51ST BRIGADE IRAQI ARMY BARRACKS
AL HILLAH, IRAQ

SIGIR PA-06-075
JANUARY 29, 2007

SUBJECT: Report on 51st Brigade Iraqi Army Barracks, Al Hillah, Iraq
(Report Number SIGIR PA-06-075)

Site Photo 5. Aluminum doors at front entrance to the barracks sleeping quarters

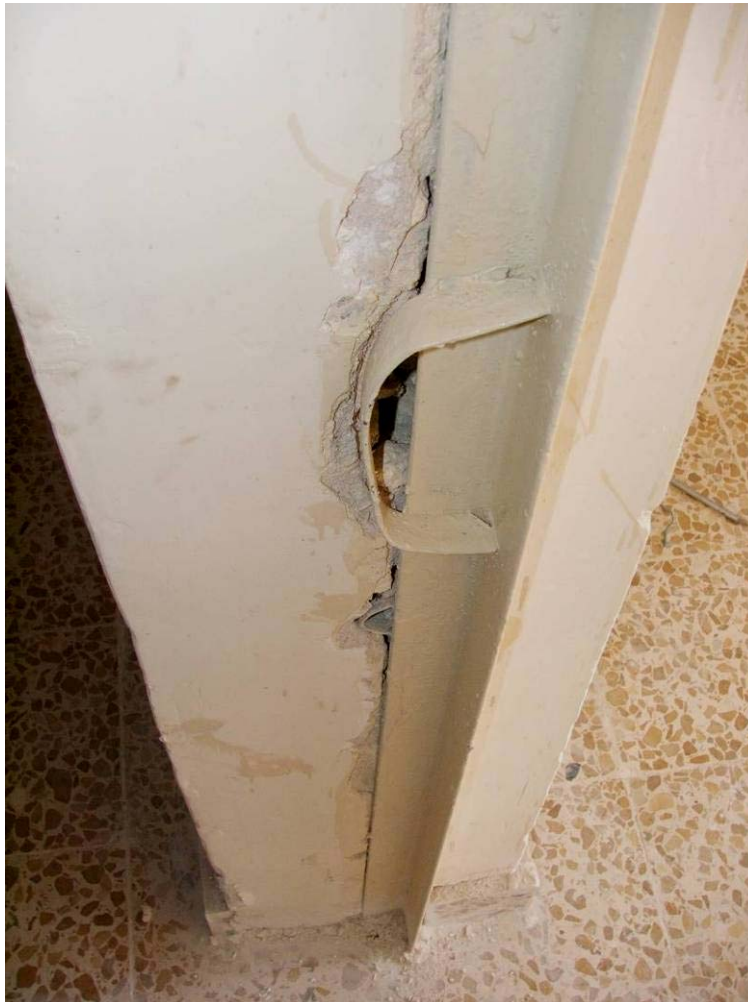
The SOW also required “good quality” aluminum windows and aluminum doors in the barracks sleeping quarters. In our inspection, we observed two sets of aluminum entry/exit doors in the sleeping quarters, one set of double doors serving as the front entrance, and a single door in the rear of the building. These doors did not appear to be “good quality,” especially considering the high traffic that a 75-man barracks will receive. Site Photo 5 shows the aluminum doors used for the entrance to the barracks sleeping quarters, and Site Photo 6 shows the rear entrance/exit door in one of the two barracks.

Figure 1. Design detail for covered parking (sunshade)

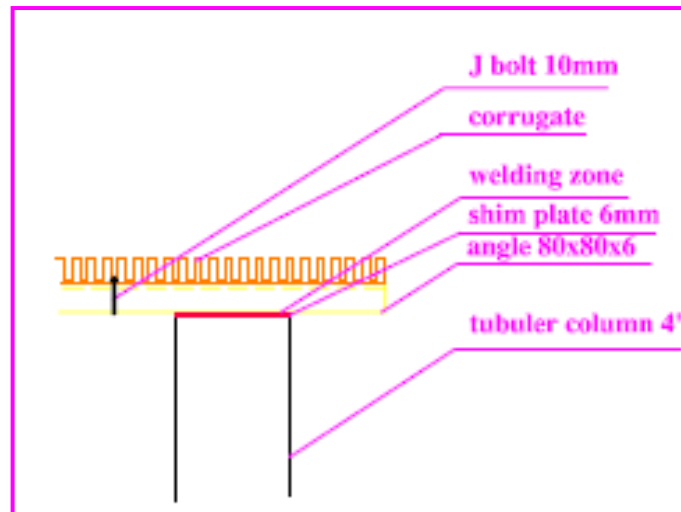
The design detail for the structural frame supporting the corrugated roof sheeting (Figure 1) showed an 80 x 80 x 6 angle supporting the roof sheeting. No units were provided for the angle, although it is assumed the dimensions are in millimeters. Figure 1 also shows the angle welded to a shim plate at the top of the column. There were no details provided on the type or size of weld or the type and thickness of the corrugated roof sheeting. The design also did not show any lateral cross bracing perpendicular to the angle support shown in Figure 1.

Site Photo 14. Typical column support for covered parking (sunshade)

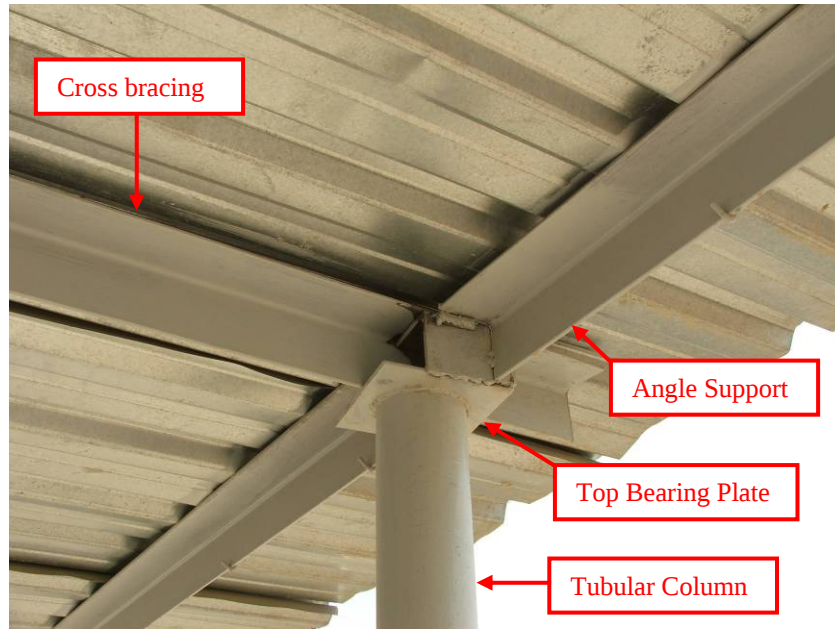
Site Photo 14 shows the actual welded angle connections at the bearing plate (i.e., shim plate) at the top of each tubular column, as well as, the lateral cross bracing. The roof sheeting material appeared to be a thin gage sheet metal, connected to the frame with J-bolts, as depicted in Figure 1.

Site Photo 15. Torn sheeting at one end of the parking sunshade

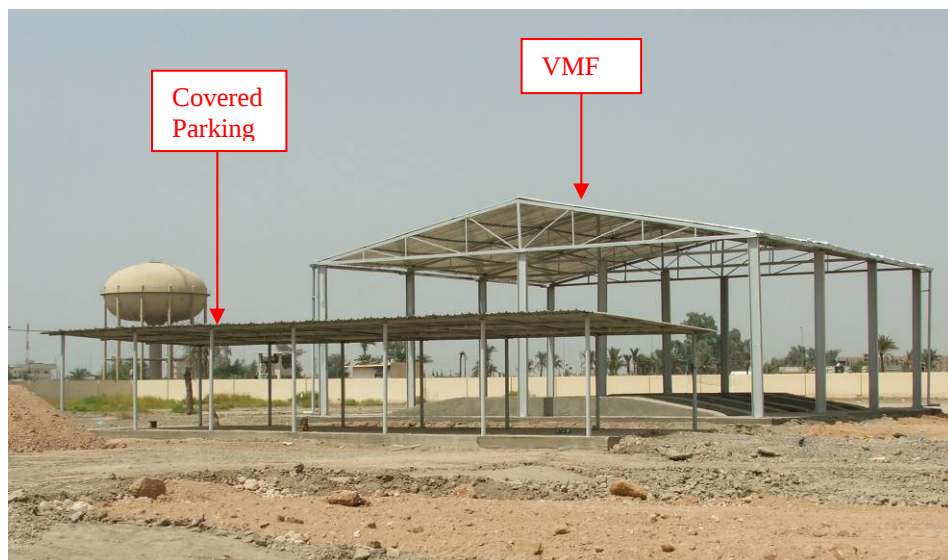
At one end of the sunshades, a portion of the metal sheeting was torn away at the corner (Site Photo 15). We also observed broken concrete at the base of one of the four inch tubular columns (Site Photo 16). Both of these items should be included in the punch list generated at final inspection.
